PARIS#13

PROJECT: PARIS #13		
DESIGN TITLE: BUILT VERSION OPTIMIZATION 01		
AUTHOR: CH'TI LAMPES	DRAWING NUMBER Drawing_nr	REV: 1H
DATE: 2017-05-14	SIZE: A4	SHEET: 1 of 1

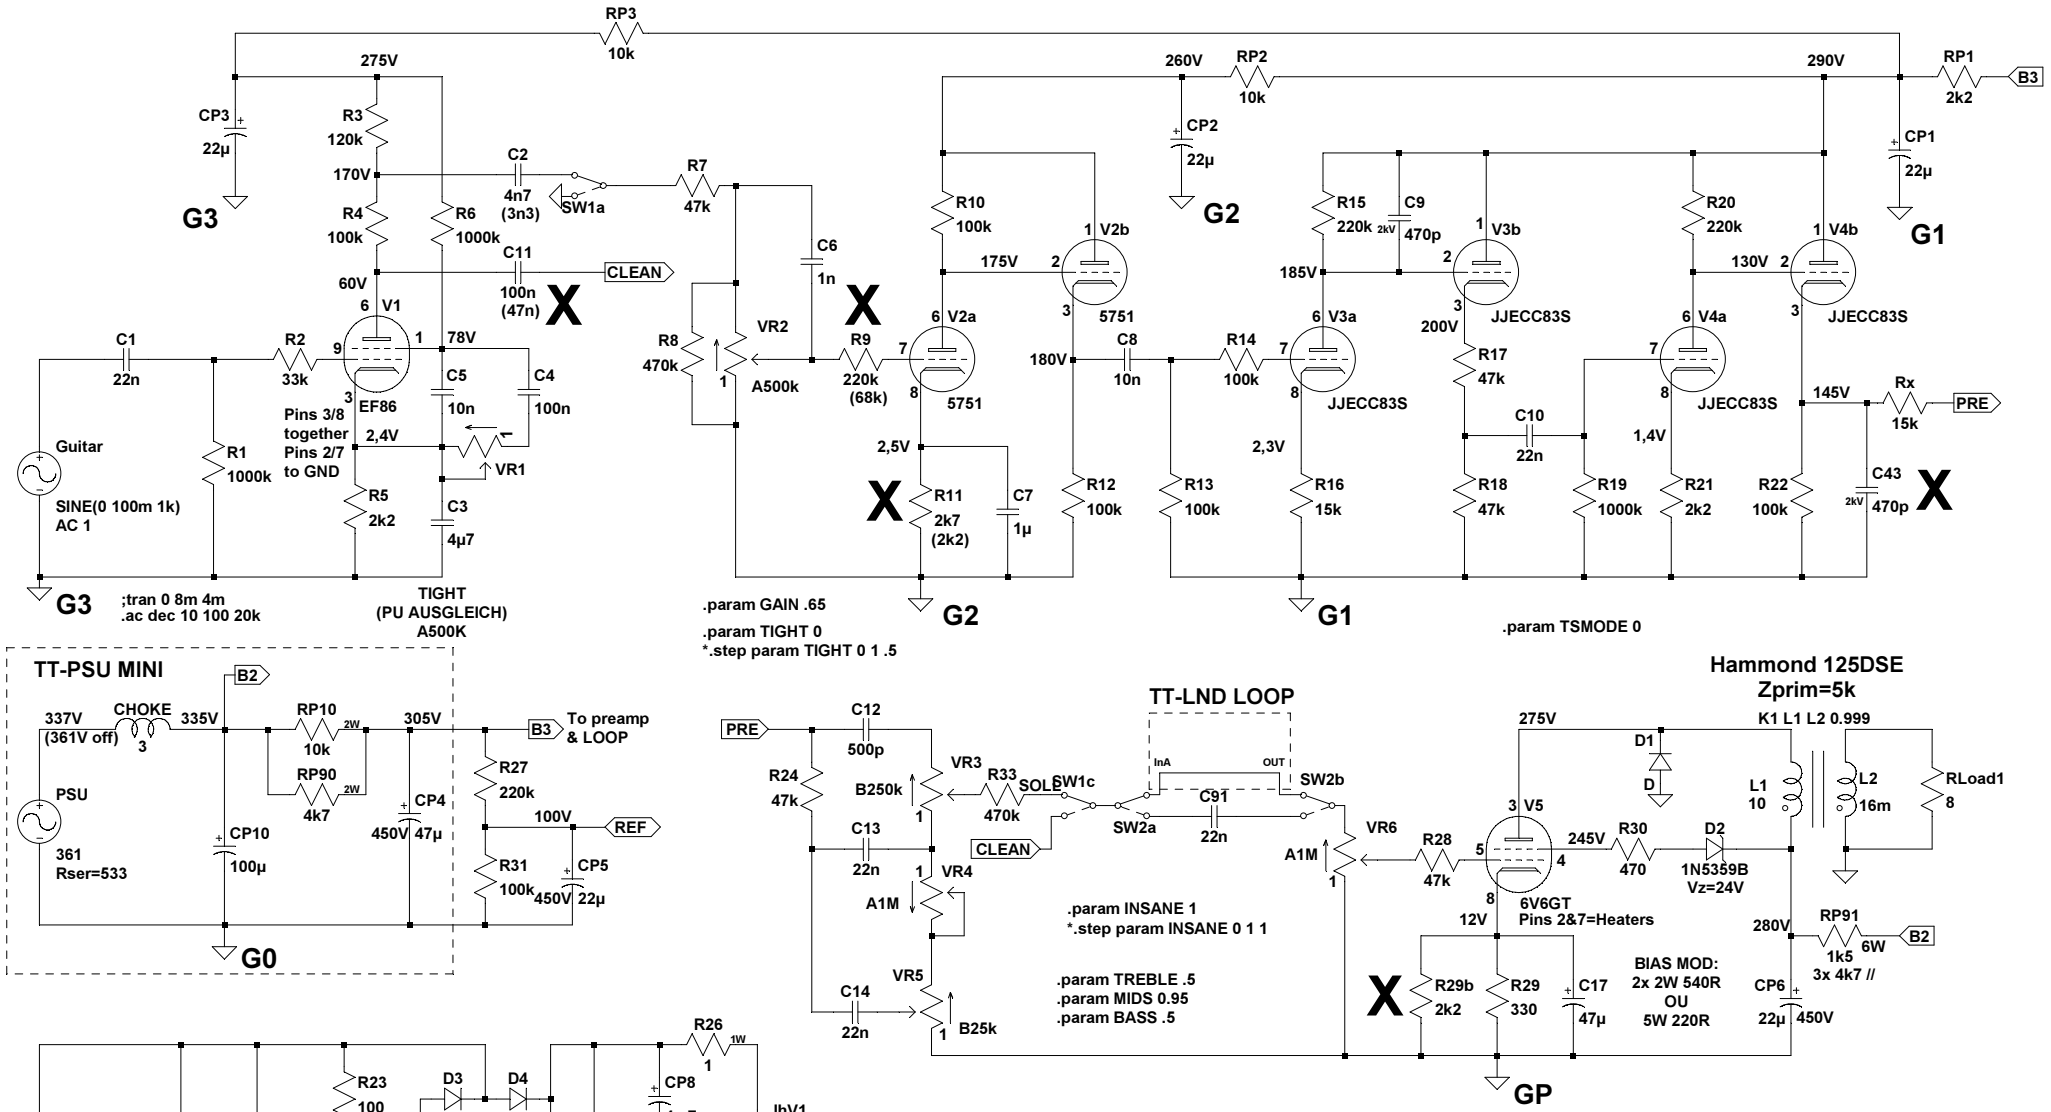
- Modified voicing of lead channel
- Swapped OT for 125DSE
- Adjusted bias 6V6
- Increased C11 to raise bass response (cut through C91)
